AUS920010751US1

D. AMENDMENTS TO THE DRAWINGS

Applicant submits three replacement sheet drawings (see section F) and requests amendment of the drawings as follows:

FIG. 4

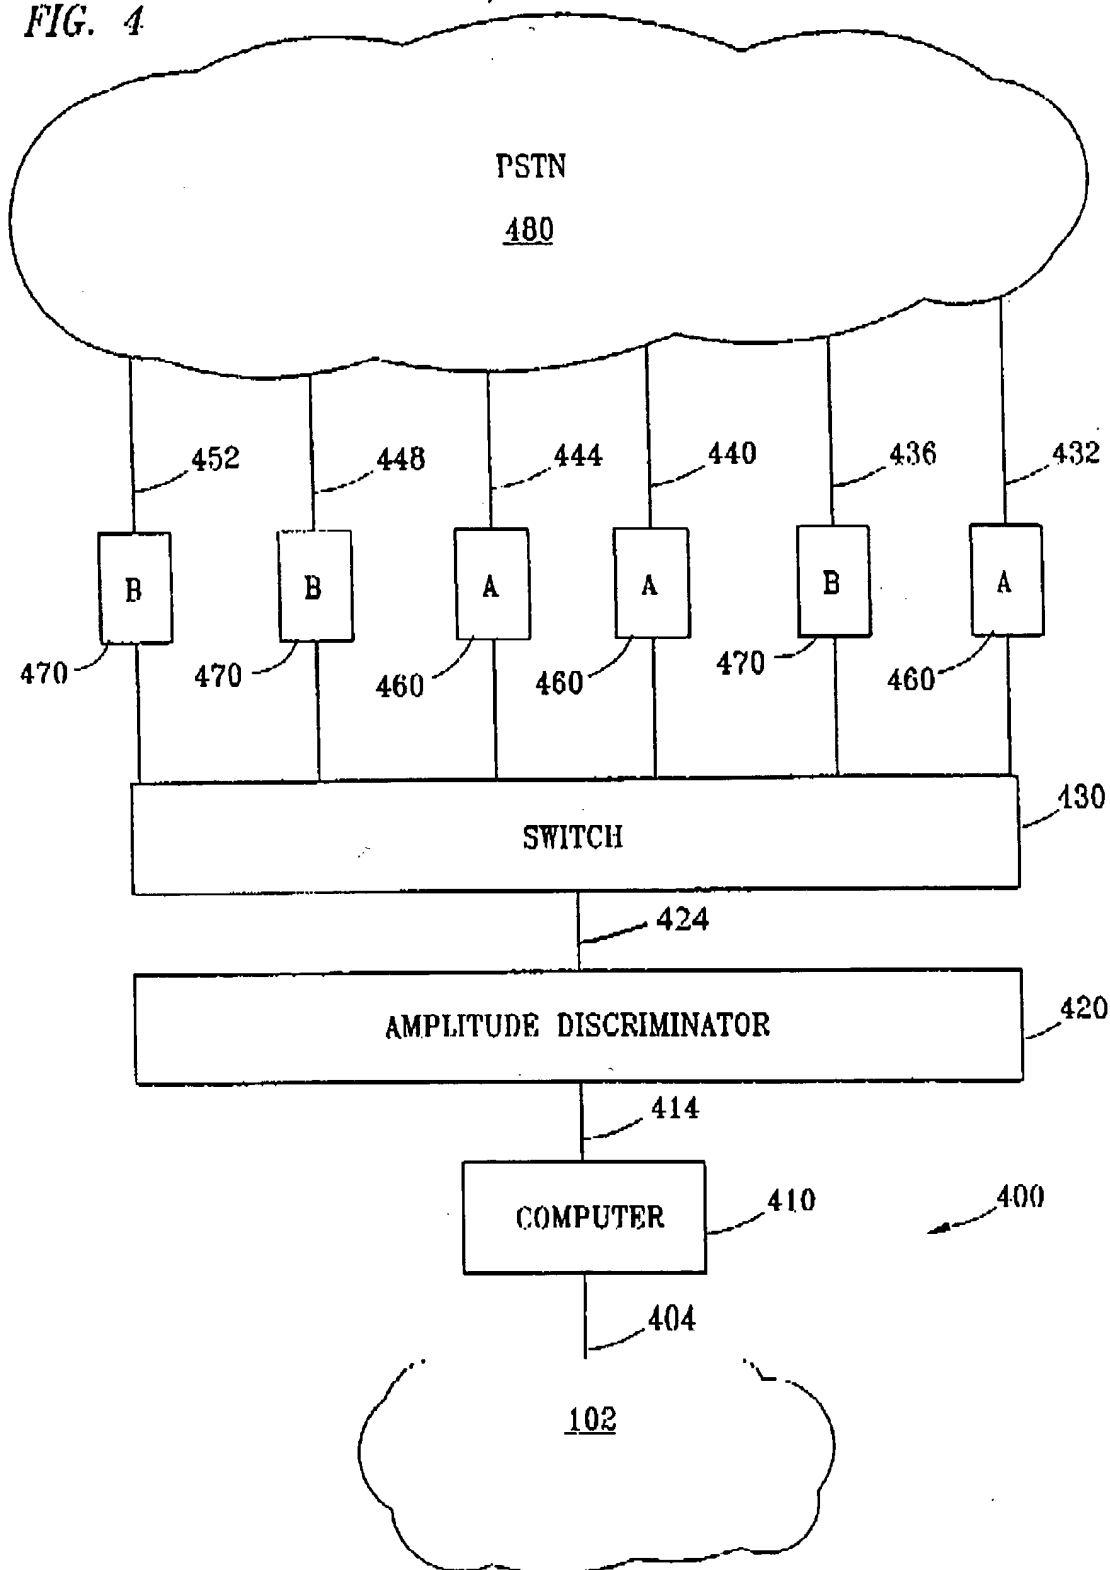
Sheet 3/15, FIG. 4 has been amended to add the numeral 424 to the line connecting switch 430 and amplitude discriminator 420. On page 8, lines 22- page 9, line 1, the specification states "Amplitude discriminator 420 is connected to switch 430 by line 424. The numeral 424 was inadvertently left off the original drawings, and a substitute drawing is provided attached to this response.

FIG. 5

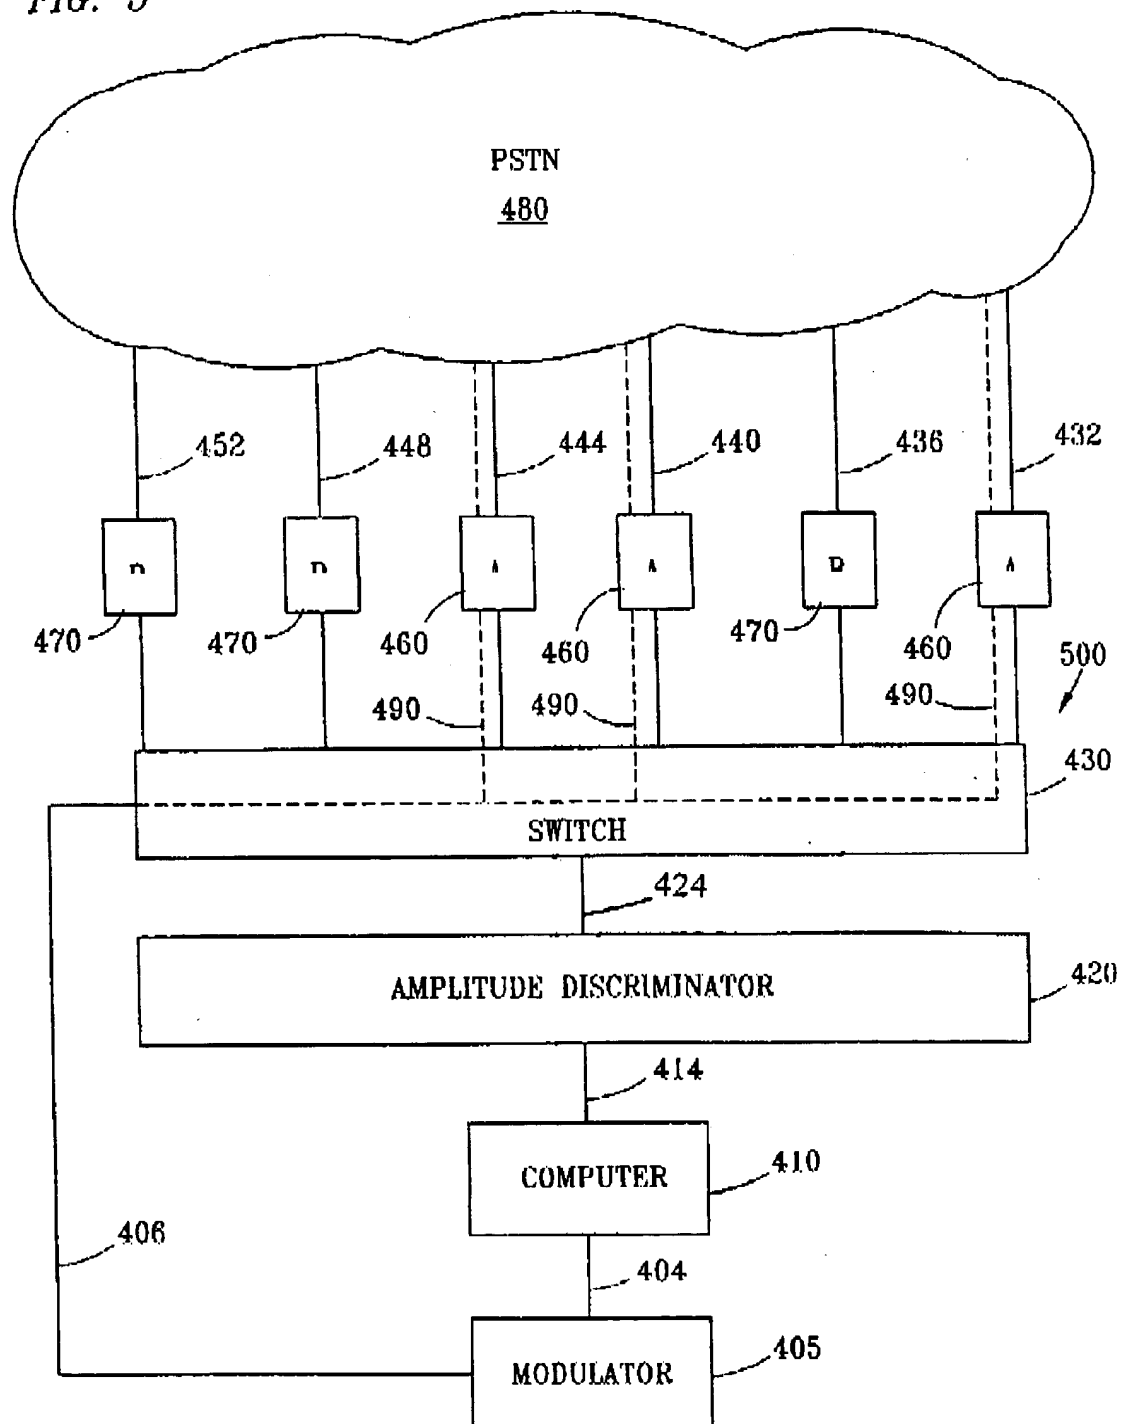
Sheet 4/5, FIG. 5 has been amended to add the numeral 424 to the line connecting switch 430 and amplitude discriminator 420. On page 9, lines 18-19, the specification states "[a]mplitude discriminator 420 is connected to switch 430 by line 424." The numeral 424 was inadvertently left off the original drawing, and a substitute drawing is provided attached to this response for correction.
